CALENDAR ITEM
74

CONSIDER APPROVAL OF PROPOSED REGULATORY AMENDMENTS TO THE 2013 CALIFORNIA BUILDING CODE, CALIFORNIA CODE OF REGULATIONS, TITLE 24, PART 2, CHAPTER 31F – MARINE OIL TERMINALS

LEGEND FOR FINAL EXPRESS TERMS (combination of 45-day and 15-day changes)
1. For 45-day and 15-Day changes, existing California amendments or code language being modified appears in *italics*, with modified language underlined.
2. For 45-day and 15-Day changes, repealed text appears in ~~strikeout~~.

FIGURE 31F-4-2
PILE-DECK CONNECTION MODELING FOR PRESTRESSED CONCRETE PILE (ADAPTED FROM [4.2])

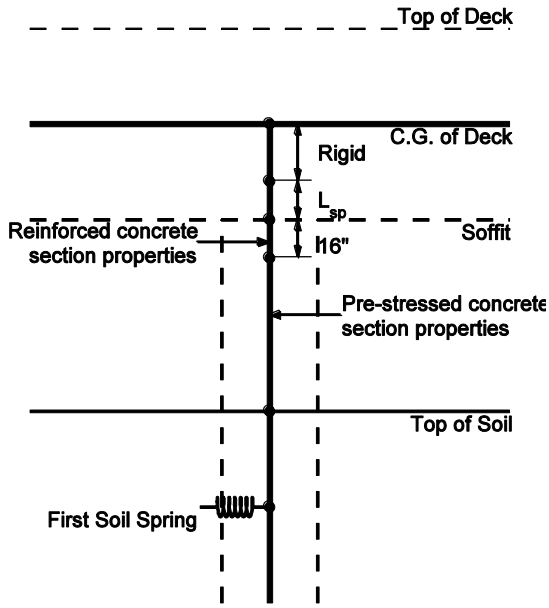
4.11. ***3104F.2.3.1.1 Modeling.*** *A series of nonlinear pushover analyses may be required depending on the complexity of the MOT structure. At a minimum, pushover analysis of a two-dimensional model shall be conducted in both the longitudinal and transverse directions. The piles shall be represented by nonlinear elements that capture the moment-curvature/rotation relationships for components with expected inelastic behavior in accordance with Section 3107F. The effects of connection flexibility shall be considered in pile-to-deck connection modeling. For prestressed concrete piles, Figure 31F-4-2 may be used. A nonlinear element is not required to represent each pile location. Piles with similar lateral force-deflection behavior may be lumped in fewer larger springs provided that the overall torsional effects are captured.*

4.12. Add new Figure 31F-4-2:

FIGURE 31F-4-4
IDEALIZATION OF PUSHOVER CURVE (ADAPTED FROM [4.3])

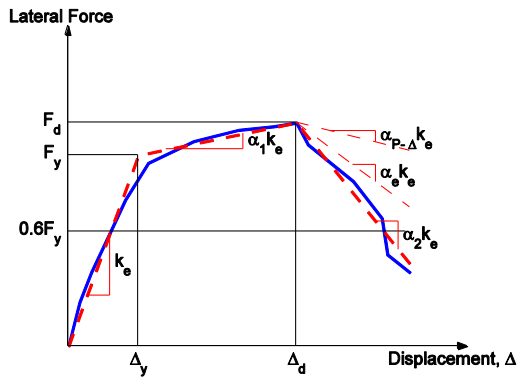
The first step in the Coefficient Method requires idealization of the pushover curve to calculate the effective elastic lateral stiffness, k_e, and effective yield strength, F_y, of the structure as shown in Figure 31F-4-4.

4.19. Add new Figure 31F-4-4:

FIGURE 31F-4-7
EFFECTIVE LATERAL STIFFNESS (ADAPTED FROM [4.4])

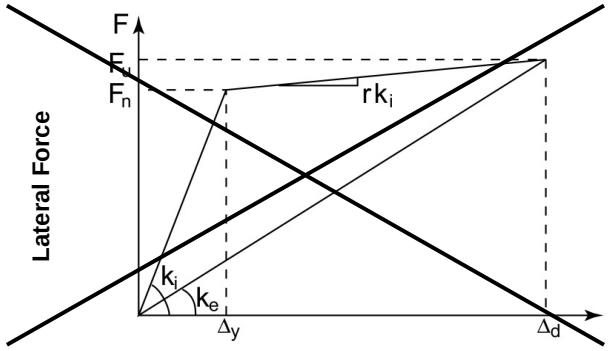
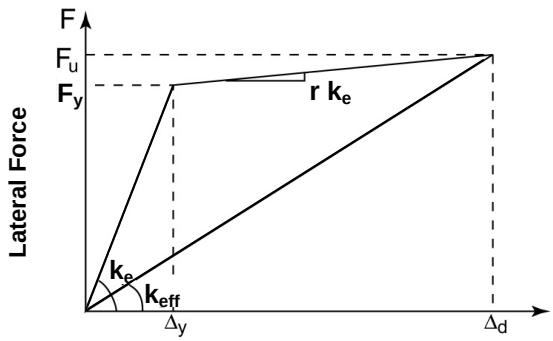
12~~10~~. Repeat the process until a satisfactory solution is obtained (see Figure 31F-4-7 ~~31F-4-5~~).

4.26. Remove entirely:

~~FIGURE 31F-4-5~~
~~EFFECTIVE STIFFNESS, k_e [4.1]~~

4.27. Add new Figure 31F-4-7:

FIGURE 31F-4-9
PLAN VIEW OF WHARF SEGMENT UNDER X AND Y SEISMIC EXCITATIONS

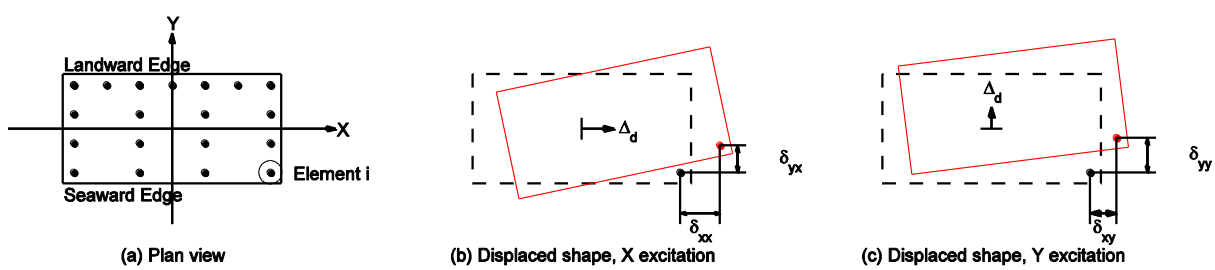
4.33. ***3104F.4.2 Combination of orthogonal seismic effects.*** *The design displacement demand at an element, δ_d, ~~Δ_d,~~ shall be calculated by combining the longitudinal, δ_x, ~~Δ_x,~~ and transverse, δ_y, ~~Δ_y,~~ displacements in the horizontal plane (Figure 31F-4-9 ~~31F-4-7~~):*

4.34. Remove entirely: ~~***FIGURE 31F-4-7 PLAN VIEW OF WHARF SEGMENT UNDER X AND Y SEISMIC EXCITATIONS [4.3]***~~

4.35. Add new Figure 31F-4-9:

FIGURE 31F-6-1
AXIAL SOIL SPRINGS [6.8]

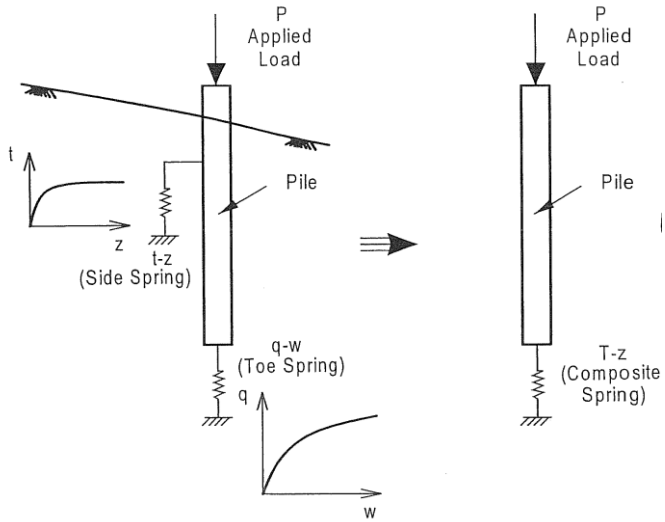
6.22. ***3106F.8.2 Axial springs for piles.*** *The geotechnical analyst (see Section 3102F.3.4.8) shall coordinate with the structural analyst (see Section 3102F.3.4.4) and develop axial springs (T-z) for piles. The T-z springs may be developed either at the top or at the tip of the pile (see Figure 31F-6-1). If the springs are developed at the pile tip, the tip shall include both the friction resistance along the pile (i.e., side springs [t-z]) and tip resistance at the pile tip (i.e. tip springs [q-w]), as illustrated in Figure 31F-6-1. If T-z springs are developed at the pile top, the appropriate elastic shortening of the pile shall be included in the springs. Linear or nonlinear springs may be developed if requested by the structural analyst.*

6.23. Add new Figure 31F-6-1 :

FIGURE 31F-6-2
SLIDING LAYER MODEL [6.8]

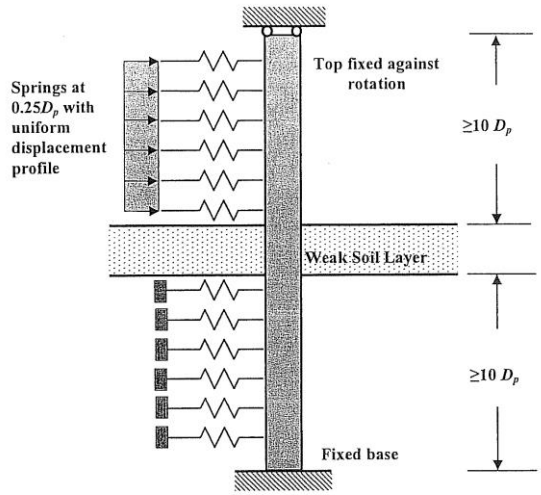
3. *For a simplified analysis (see Figure 31F-6-2), the pile shall be fixed against rotation and translation relative to the soil displacement at some distance above and below the weak soil layer. Between these two points, lateral soil springs are provided, which allow deformation of the pile relative to the deformed soil profile.*

6.29. Add new Figure 31F-6-2 :

~~FIGURE 31F-7-4~~
~~INFLUENCE OF PILE/SOIL STIFFNESS RATIO ON PLASTIC HINGE LENGTH (after Fig 5.30 of [7.1])~~

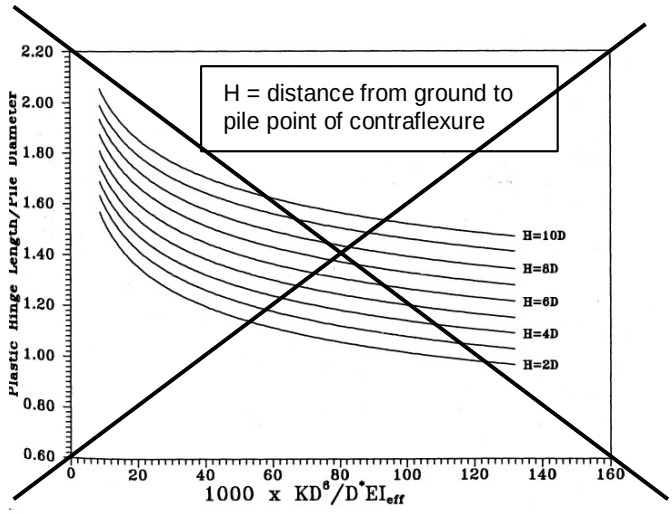
When the plastic hinge forms in-ground, the plastic hinge length may be determined using Equation (7-7) [7.5]: ~~from Figure 31F-7-4 (see page 311 of [7.1]).~~

7.2. Remove entirely:

FIGURE 31F-7-4 ~~31F-7-5~~
METHOD A – MOMENT CURVATURE ANALYSIS

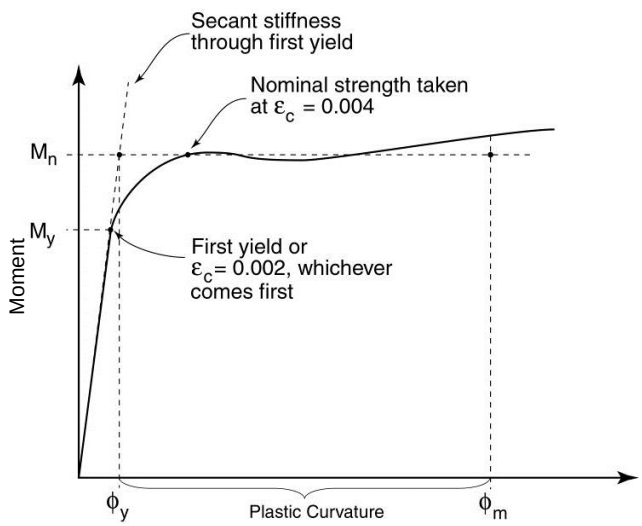
7.7.

FIGURE 31F-7-5
METHOD B – MOMENT CURVATURE ANALYSIS [7.6]

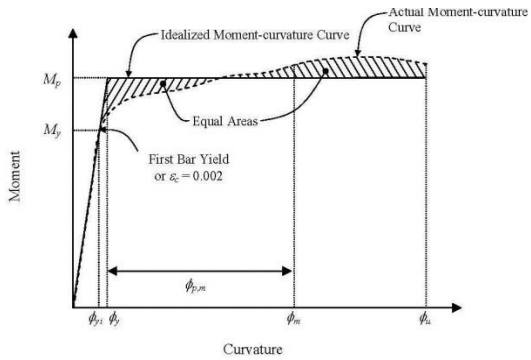
7.8. ***3107F.2.5.4.2 Method B.*** *For Method B, the elastic portion of the idealized moment-curvature curve is the same as in Method A (see Section 3107F.2.5.4.1). However, the idealized plastic moment capacity, M_p, and the yield curvature ϕ_y, is obtained by balancing the areas between the actual and the idealized moment-curvature curves beyond the first yield point (see Figure 31F-7-5). Method B applies to moment-curvature curves that do not experience reduction in section moment capacity.*

7.9. Add new Figure 31F-7-5:
